Safety Evaluation of Safety Valve Setpoint Tolerance Relaxation

Prepared for
Tennessee Valley Authority
Sequoyah Nuclear Plant, Units 1 & 2

PROPOSED TECHNICAL SPECIFICATION (TS) CHANGE

REVISED UPDATED FINAL SAFETY ANALYSIS REPORT PAGES

Figure 15.5.5-1 Steam Generator Tube Rupture - Thyroid Dose

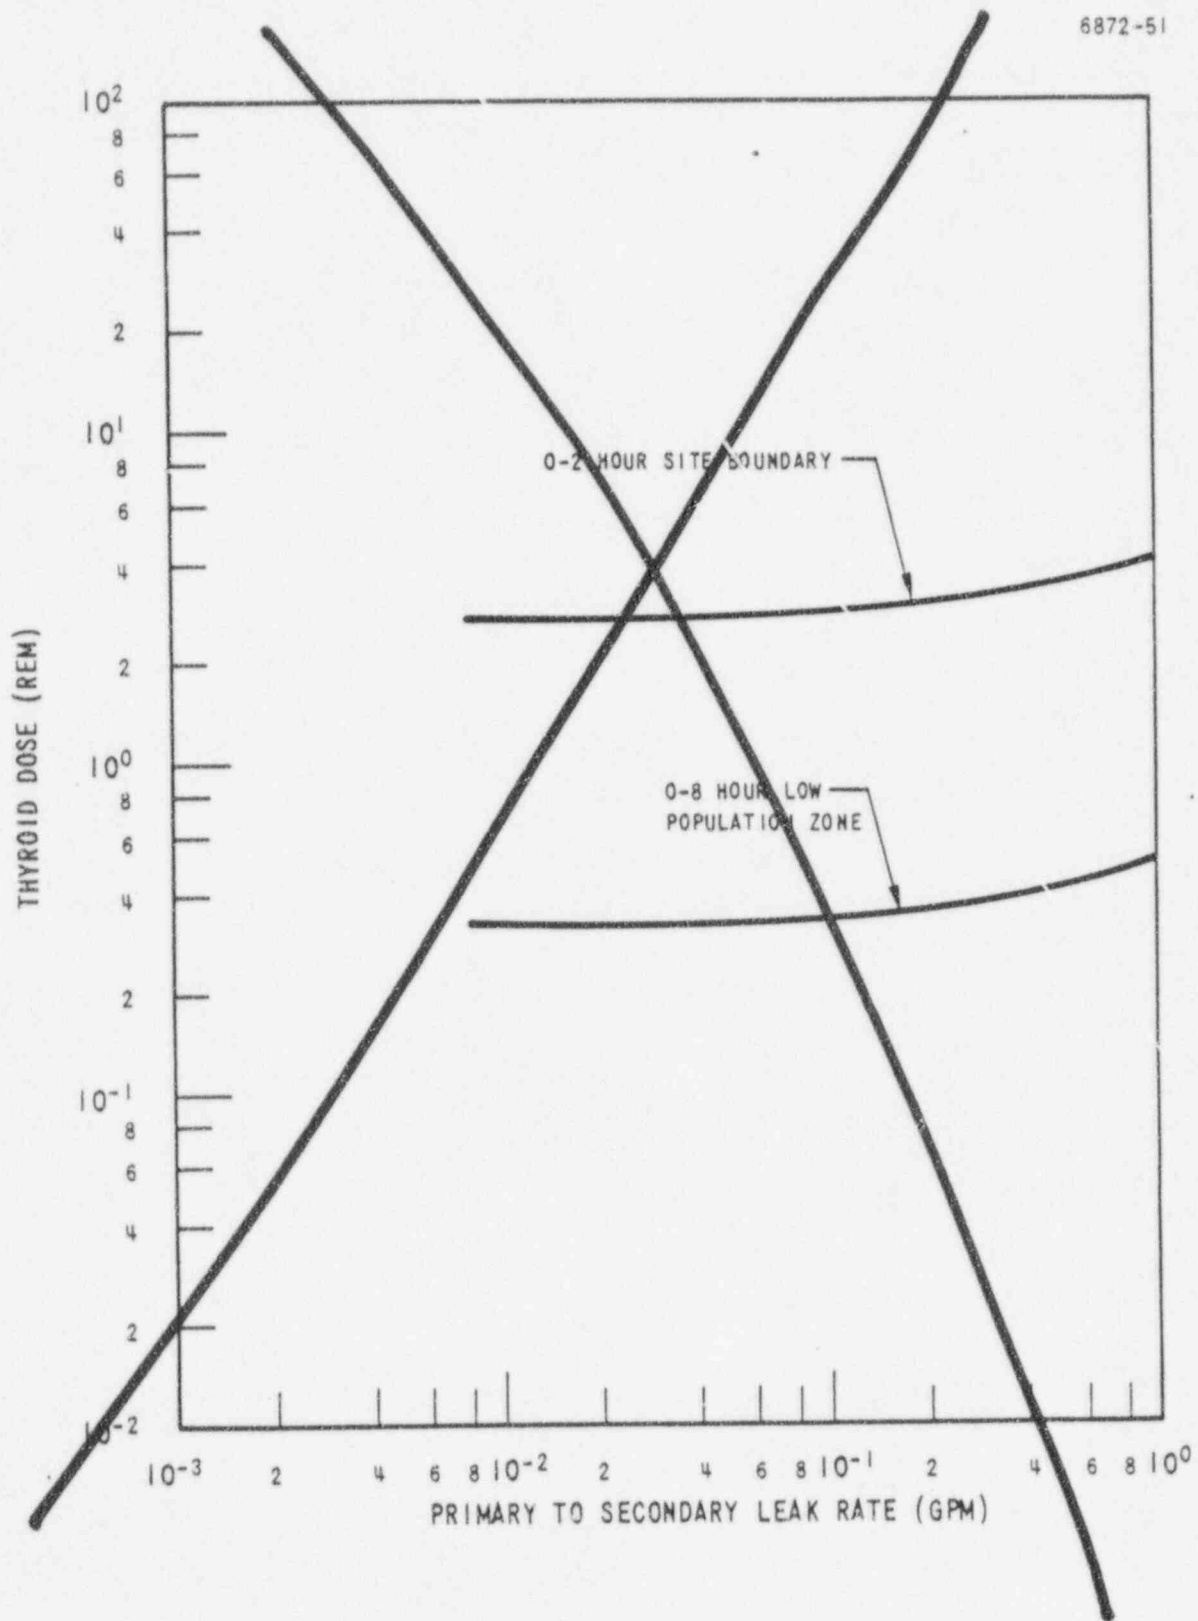
| <u>Number</u> | <u>Title</u> |
|---------------|---|
| 15.5.5-1 | Steam Generator Tube Rupture - Thyroid Dose Delete |

Delete

Figure 15.5.5-2 Steam Generator Tube Rupture - Beta Dose

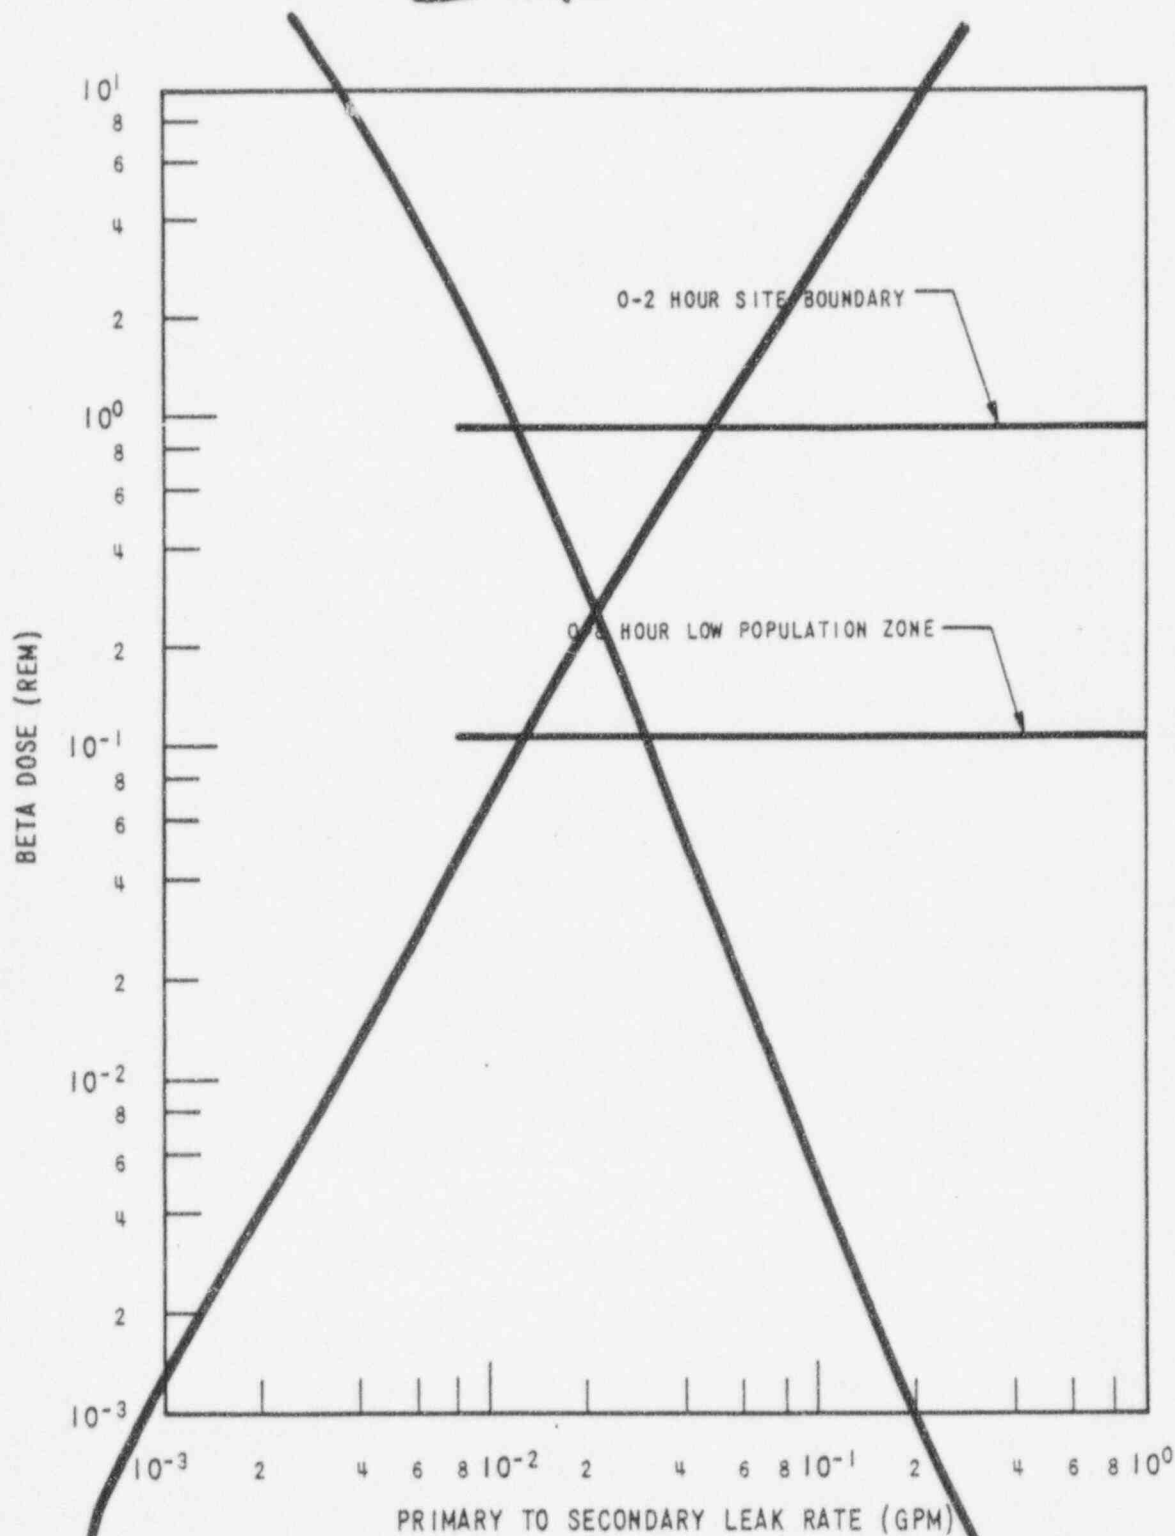
| <u>Number</u> | <u>Title</u> |
|---------------|---|
| 15.5.5-2 | Steam Generator Tube Rupture - Beta Dose Delete |

Delete

Figure 15.5.5-3 Steam Generator Tube Rupture - Gamma Dose

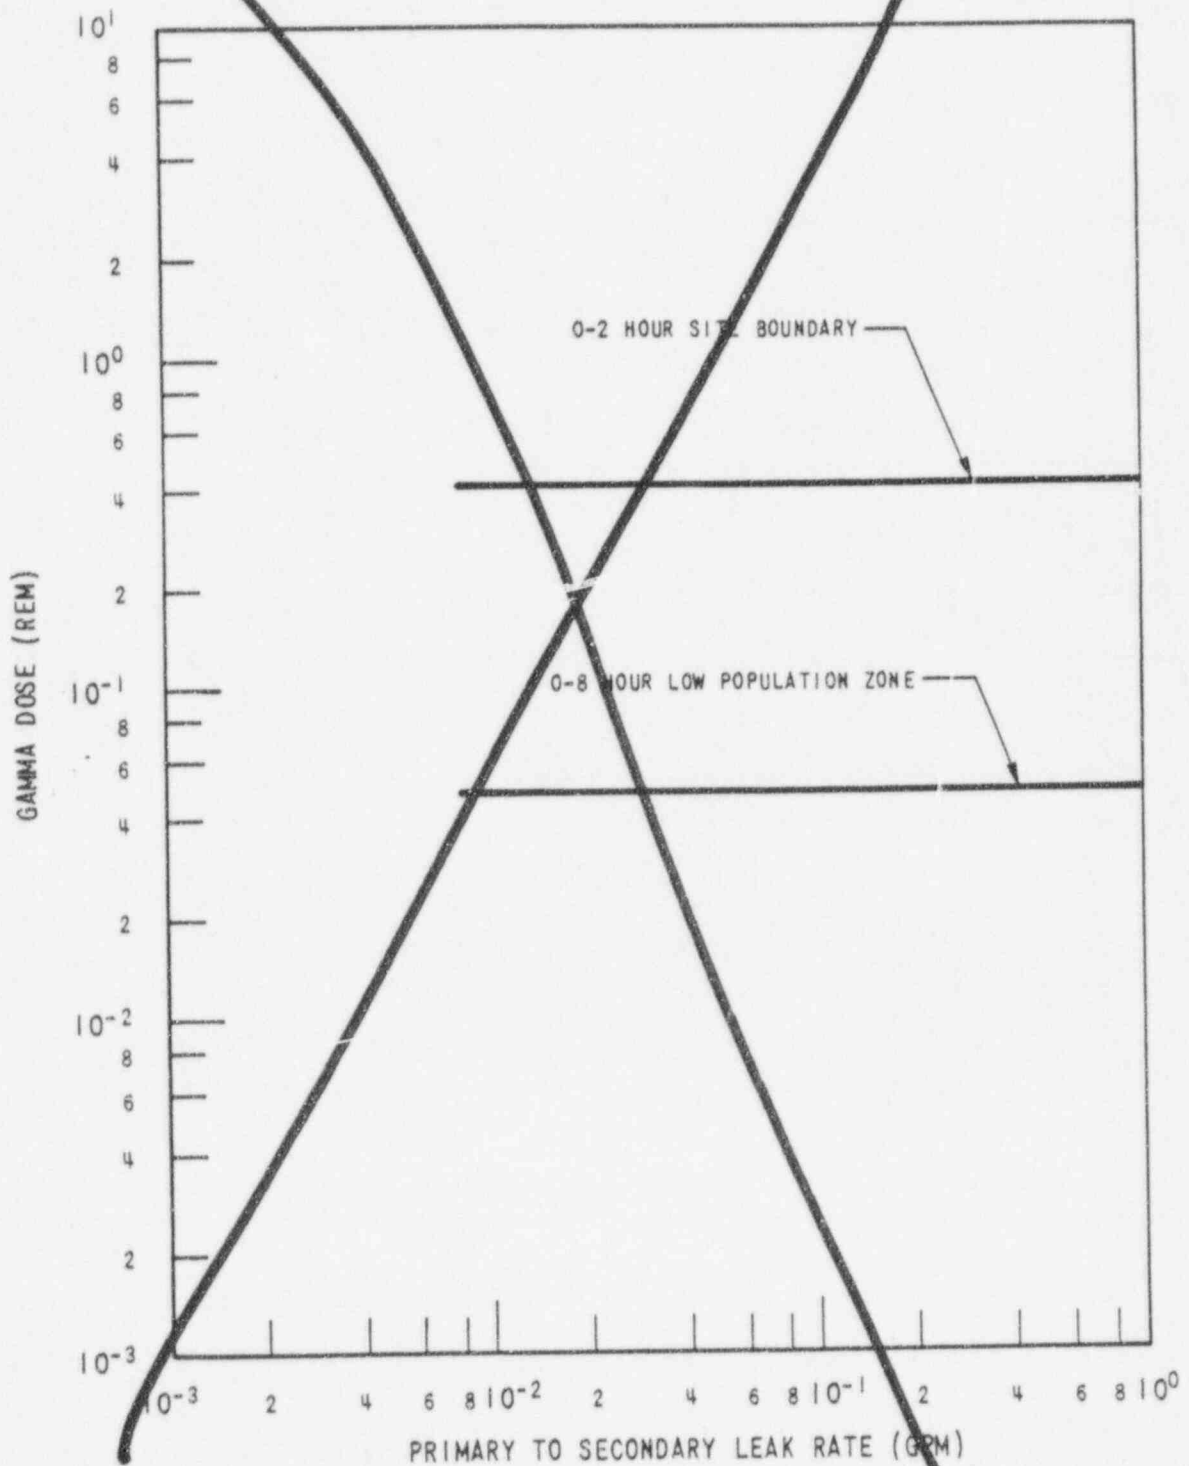
| <u>Number</u> | <u>Title</u> |
|---------------|---|
| 15.5.5-3 | Steam Generator Tube Rupture - Gamma Dose Delete |

Delete
